# UNITED STATES PATENT AND TRADEMARK OFFICE

APPLICATION NO.	FILING DATE	FIRST NAMED INVENTOR	ATTORNEY DOCKET NO.	CONFIRMATION NO.
10/600,479	06/19/2003	Seiya Asano	3702/0M969US0	6321
7278	7590	12/13/2005	EXAMINER	
DARBY & DARBY P.C. P. O. BOX 5257 NEW YORK, NY 10150-5257			NGUYEN, XUAN LAN T	
			ART UNIT	PAPER NUMBER
			3683

## Office Action Summary

## DETAILED ACTION

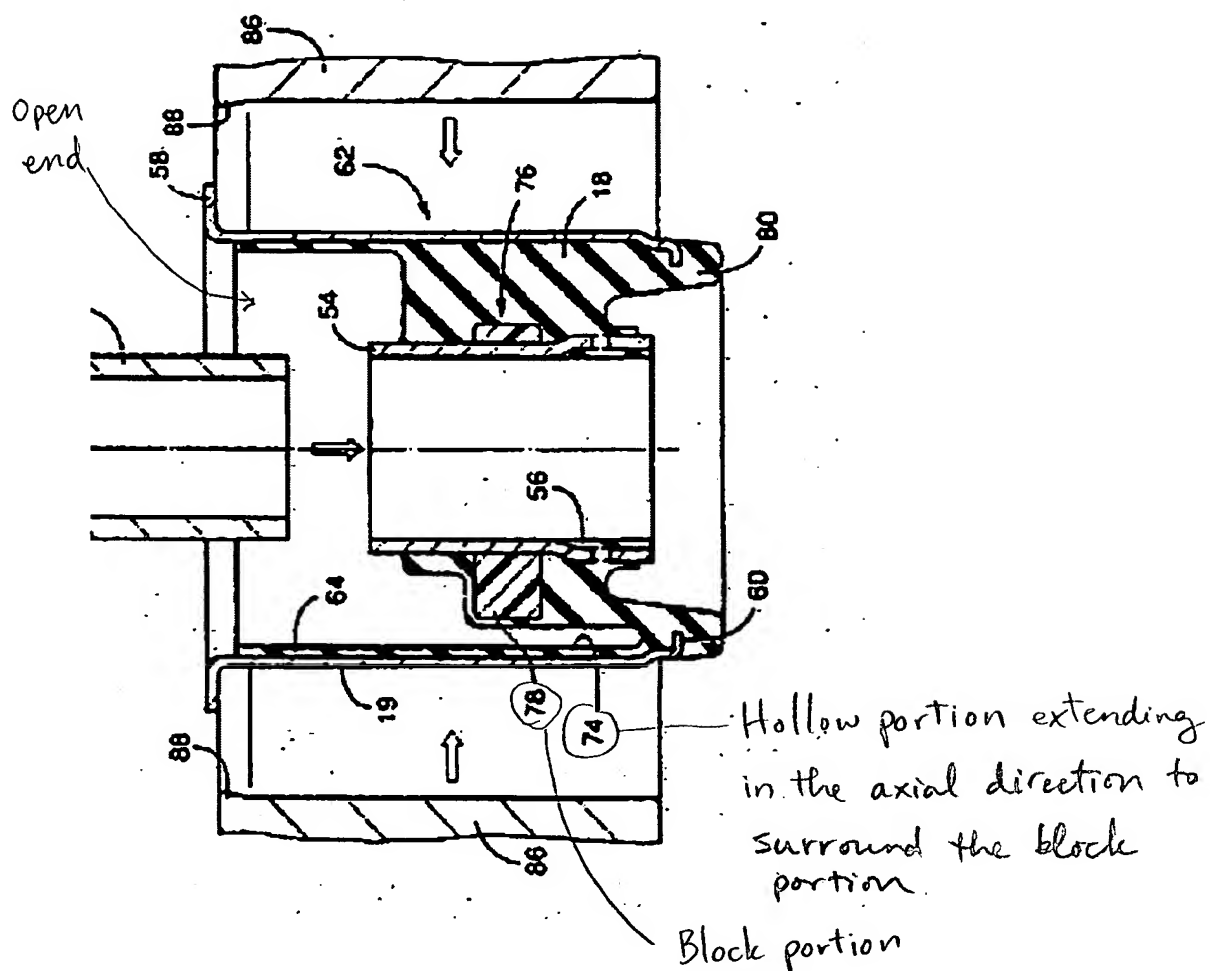
Re: claim 1, Nicholson shows a vibration isolating bushing in figure 1, as in the present invention, comprising: a main shaft member 10 including a tubular portion, a flange portion, as marked below, extending radially outwardly from one end of the tubular portion, and a block portion 13 provided on a central portion of the tubular portion and distanced from the flange portion in an axial direction of the main shaft member; an outer cylinder member 11 disposed coaxially on an outer side of the main shaft member in a distance therefrom; and a rubber elastic body 12 disposed between the main shaft member and the outer cylinder member integral connection of the main shaft member and the outer cylinder member, said rubber elastic body including a hollow portion, as marked below, which is open in an end face away from the flange portion and extends in the axial direction; wherein the rubber elastic body further includes non-deforming rubber portion, please see the figure below, and a connecting portion, see the figure below; the non-deforming rubber portion fills a gap between the

flange portion and an end face of the block portion facing the flange portion in the axial direction and is substantially undeformable with respect to an application of an axial load; the connecting portion is positioned between a bottom the hollow portion and the end face of the rubber elastic body on the side of the flange portion, for connecting the non-deforming rubber portion and an inner peripheral surface of an end portion of the outer cylinder member. Nicholson is silent of the cross-sectional shapes of the hollow portion and the block portion as claimed. Noboru et al. teach a vibration isolation bushing, especially a cross-sectional shapes of a hollow portion and a block portion, in figures 2 and 4. In figure 4, the hollow portion 74 extends to a vicinity of an end face of a block portion 78. In figure 2, the hollow portion 74 directly surrounds the block portion extending circumferentially and over a side surface to the main shaft member 56. It would have been obvious to one of ordinary skill in the art at the time the invention was made to have modified Nicholson's bushing with cross sectional shapes of a hollow portion and a block portion such as taught by Noboru et al. in order to provide a softer ride since it is well known in the art of dampening to change the spring constant of the elastomer member in order to achieve a desired dampening results as evidenced by Norobu et al.

Re: claim 2, Nicholson shows the radial outer peripheral surface of the block portion 13 to be located more inwardly than an outer peripheral end of the flange portion.

Re: claim 3, Nicholson further shows the connecting portion to be offset inwardly compared to the non-deforming portion.

【图2】

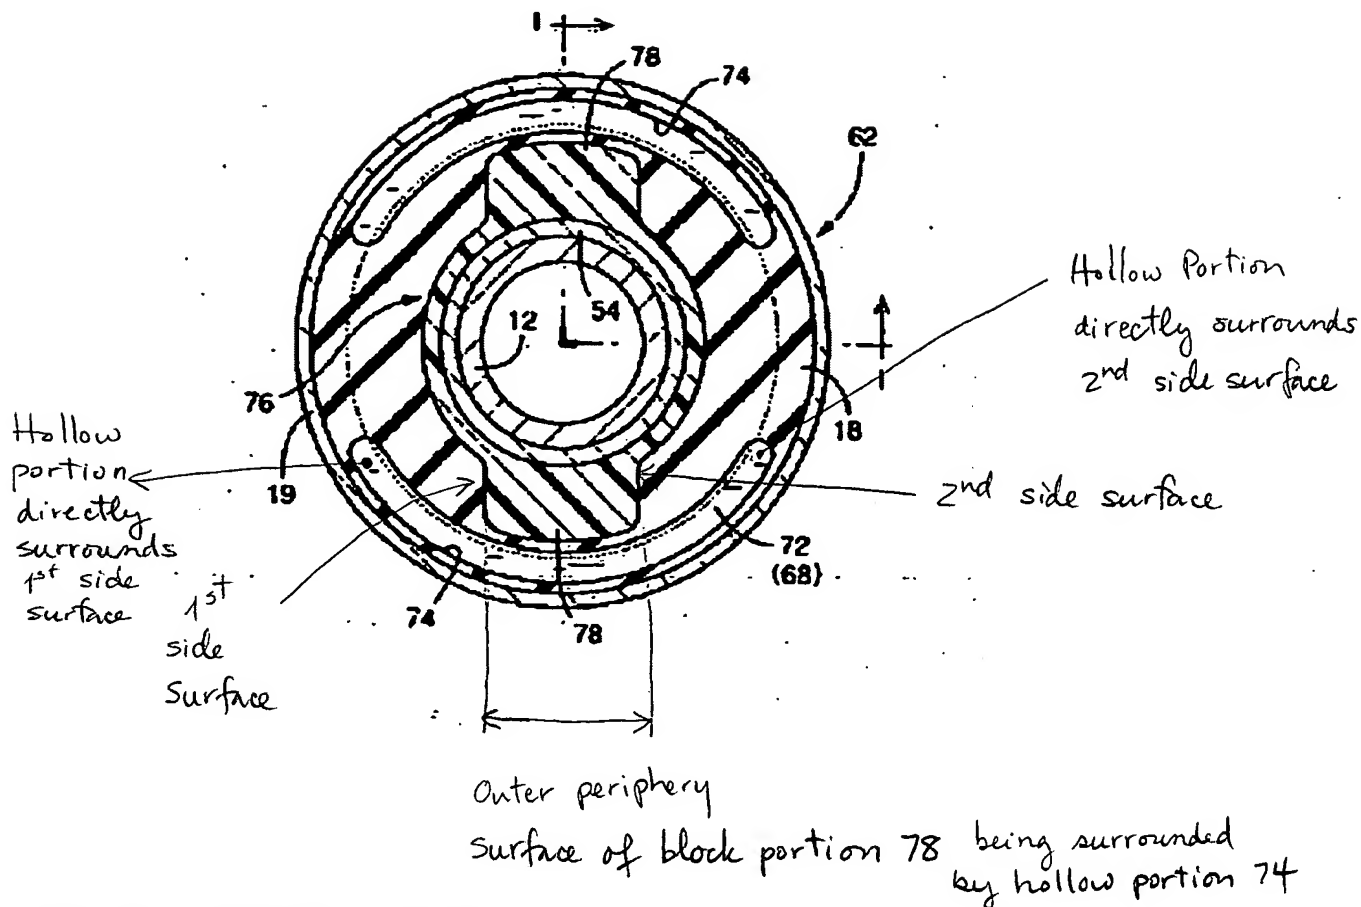
Re: claim 6, Noboru shows in figure 4 hollow portion 74 directly surrounds the side surface which extends along the axial direction, see marked up figures above.

Re: claims 7-9, Noboru further shows a second side surface of block portion 74 extending from the radial outer peripheral surface to the main shaft member 56; and the hollow portion 74 directly surrounds the second side surface which extends along the axial direction as marked above. Furthermore, the second side surface of the block portion 78 is parallel to the first side surface as shown in figure 2 of Noboru.
